Access Compliance Report

Public Rights-of-Way

Intersection ID: N/A	Main Street: BEREWICK COMMONS PKY	Cross Street: GLENBURN LN	Location: NE
ADA ID: 6B89DEA0AF9F	Ramp Type: PerpDiag	Initial Pass/Fail: Pass	Overall Compliance: No
Severity Score: 0			
Codes/Mitigation Info/Possible Solution		Field Measurements/Component Compliance

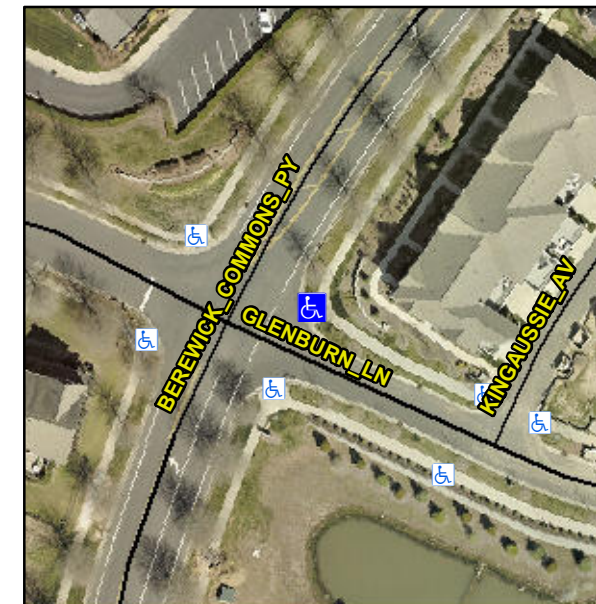
Not Found, R305.2

Compliance	Description	Data	Compliance	Description	Data
N/A	Ramp Length (in)	96.0	Yes	Ramp Slope (%)	5.3
Yes	Ramp Width (in)	48.0	Yes	Ramp XSlope (%)	0.5
N/A	Flare Type LT	Sloped	N/A	Flare Type RT	N/A
N/A	Flare Slope LT (%)	4.7	Yes	Flare Slope RT (%)	4.8
N/A	Flare Traversable LT?	Yes	N/A	Flare Traversable RT?	Yes
Yes	Landing Length (in)	60.0	Yes	DWS Provided?	Yes
Yes	Landing Width (in)	48.0	Yes	DWS Contrast?	Yes
Yes	Landing Slope (%)	0.5	Yes	DWS Length (in)	24.0
Yes	Landing X Slope (%)	0.9	Yes	DWS Full Width?	Yes
N/A	Landing Curb? (Y/N)	No	No	DWS Offset (in)	4.0
N/A	Shared Landing?	No			
Yes	Gutter Ponding?	No	Yes	Gutter Slope (%)	0.7
Yes	Gutter Lip Ht (in)	0.0	Yes	Gutter X Slope (%)	0.8
N/A	Painted X Walk1?	No	N/A	Painted X Walk2?	No
	X Walk 1 Direction	To NW		X Walk 2 Direction	To SW
N/A	X Walk 1 Width (in)	N/A	N/A	X Walk 2 Width (in)	N/A
	X Walk 1 Slope (%)	0.3		X Walk 2 Slope (%)	2.2
	X Walk 1 X Slope (%)	2.8		X Walk 2 X Slope (%)	2.2

N/A	Ramp inside XWalk1?	N/A	N/A	Ramp inside XWalk2?	N/A
	Road Slope (%)	1.1	N/A	Clear Space?	Yes
	Road X Slope (%)	1.7	N/A	Clear Space to XWalk (in)	N/A
Yes	Any Obstructions?	No	Yes	Storm Grate/Utility Hazard?	No
	Obstruction Type			Storm Grate/Utility Type	
		N/A			N/A
			Yes	Surface Condition? (G/P)	Good

Remove & Replace Curb Ramp With Two New Directional Ramps or Equivalent.
